# TECHNICAL INFORMATION

No: 76/12/99/NAS  
Ref:  
Issue: 2  
Date: 05/19/99

## Fuel Door Fails to Open

**DISCOVERY Series II (LT) Up to XA223795**

Figure 1

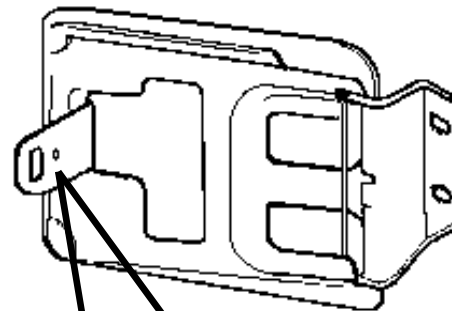
- The body buffers originally installed tend to stick to fuel flap back surface. This prohibits the door from opening consistently.
- The fuel door plastic latch may bind in its pivot hole, causing poor latching and unlatching.
- The actuator rod grommet can dislodge, jamming the latch and mechanism.
- Improper latch alignment can cause poor latching and unlatching.

2. Refer to Figure 1. Center a hand held 13mm (½ inch) drill bit on the plastic door latch pivot hole of the fuel door tab.
3. Carefully rotate the drill by hand to remove paint and material from a localized area **on the back** of the fuel door tab around the latch pivot hole.
4. Thoroughly clean the bare metal and surrounding area of the tab.
5. Apply a sparing amount of Dinitrol® (RTC7769/25) to exposed metal on the tab.
6. Continue with repair procedure while Dinitrol® is drying.

Figure 2

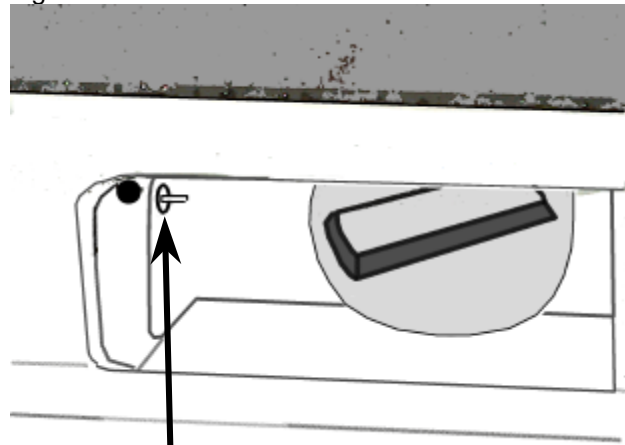
**CAUTION:** Adhesive on the inside diameter of actuator rod grommet could cause binding or other impairment to rod actuation.

2. Apply Loctite 4210 to backside of grommet shoulder.
3. Install grommet into body opening.
4. Clean off any excess adhesive and ensure that no adhesive has found its way into inside diameter of grommet where actuator rod travels.

Figure 4

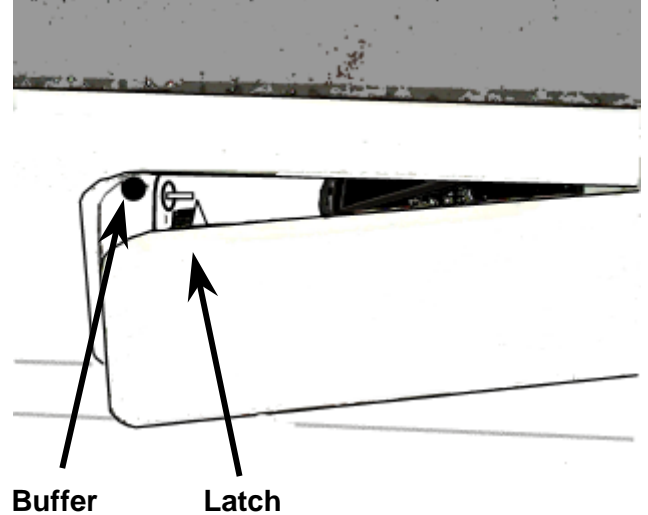
**CAUTION:** Insure that the tab and latch do not make contact with the end of the actuator rod or face of actuator rod grommet.

3. Refer to Figure 4. Carefully bend filler door tab as required to align face of plastic latch parallel to the body at actuator rod.
4. Verify that there is no contact between the latch and the grommet or between the actuator rod and the filler door tab.
5. Latch and unlatch fuel door 3 times to verify correct operation.
